Access Compliance Report Public Rights-of-Way (Curb Ramps)

Main Street: YORBA_ST Cross Street: FAIRHAVEN_AVE Location: NE

ADA ID: RPRK220126123507 Ramp Type: Type 1 - Perpendicular Diagonal Initial Pass/Fail: Fail Overall Compliance: No Severity Score: 16

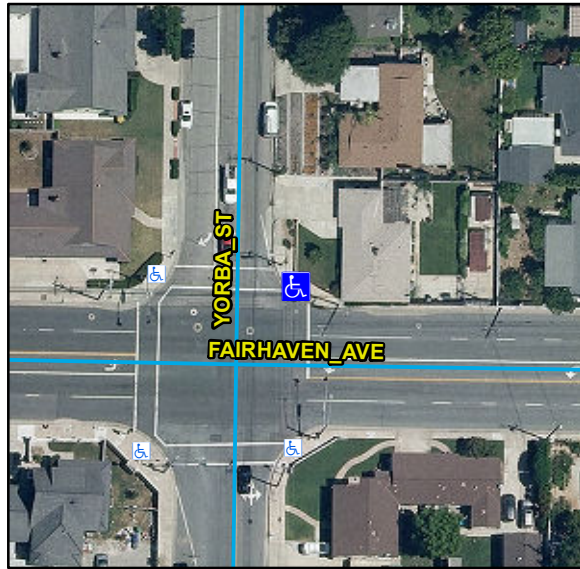
Remove & Replace Curb Ramp With Two New Directional Ramps or Equivalent. Restripe Crosswalk.

R304.2.2, R204.3, R302.7.2, STD 1115
